TECHNICAL ORDER
NO. 01-100LAA-24

30 March 1950

MODIFICATION OF LANDING GEAR - L-17A (RYAN)

Figure 1

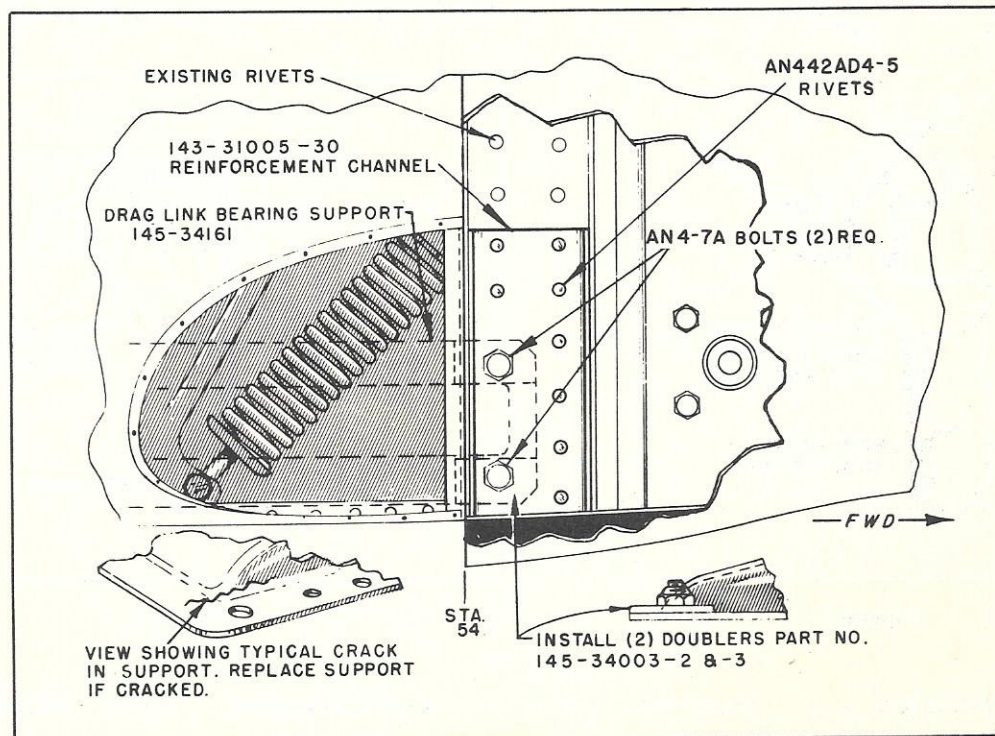
(3) Through the gill opening, inspect forward end of support channel-nose gear drag brace bearing support, part No. 145-34161, for cracks in the radius of the flange where two bolts, part No. AN4-6A, attach part to firewall channel located on the opposite side. (See figure 1.)

(5) Remove bolts and rivets from lower end of the right-hand side of channel (firewall to nose gear torque box), part No. 143-31005-6, in area that would be covered by reinforcement channel, part No. 143-31005-30. (See figure 1.)

(6) Install reinforcement channel, part No. 143-31005-30, onto channel, part No. 143-31005-6, with eight rivets, part No. AN442AD4-5, using existing rivet holes.

(7) Replace bolts, part No. AN4-6A, with bolts, part No. AN4-7A. Under the nut of each bolt, install doubler, part Nos. 145-34003-2 and 145-34003-3, in lieu of AN washers. (See figure 1.)

Figure 2

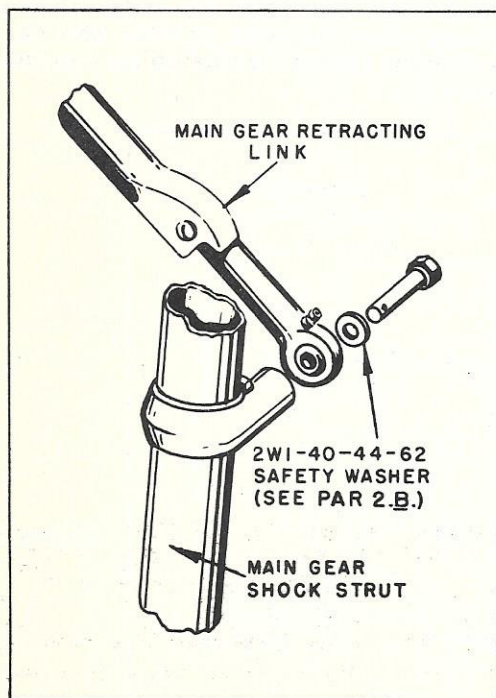
(1) Install safety washer, part No. 2W1-40-44-62, on left and right main landing gear retracting link strut attaching bearing in lieu of washers, part No. AN960-1016. (See figure 2.)

Figure 3

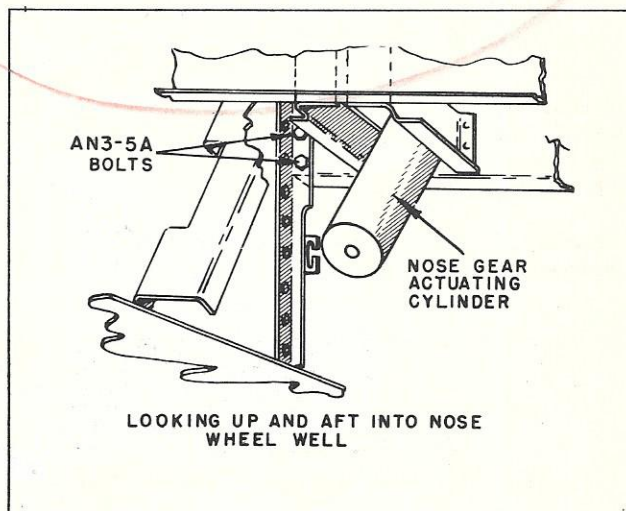
(1) Inspect the nose wheel well area, at the gear retracting cylinder attaching cross member, where the ends attach to nose wheel well side spar, right-hand side upper corner (figure 3), and determine if two proper 3/16-inch high shear rivets are installed. If two 1/8-inch rivets are installed, remove rivets and redrill holes using a No. 12 (.189-inch diameter) drill. Install two each bolts, part No. AN3-5A, washers, part No. AN960-10; and nuts, part No. AN365-1032.

(2) On the left-hand side, upper corner (opposite end of the above), determine if two proper 5/32-inch dural rivets are installed. If two 1/8-inch rivets are installed, drill out rivets and install two each rivets, part No. AN442AD5-5, or drill out holes with No. 12 (.189-inch diameter) drill, and install two each bolts, part No. AN3-5A; washers, part No. AN960-10; and nuts, part No. AN365-1032.
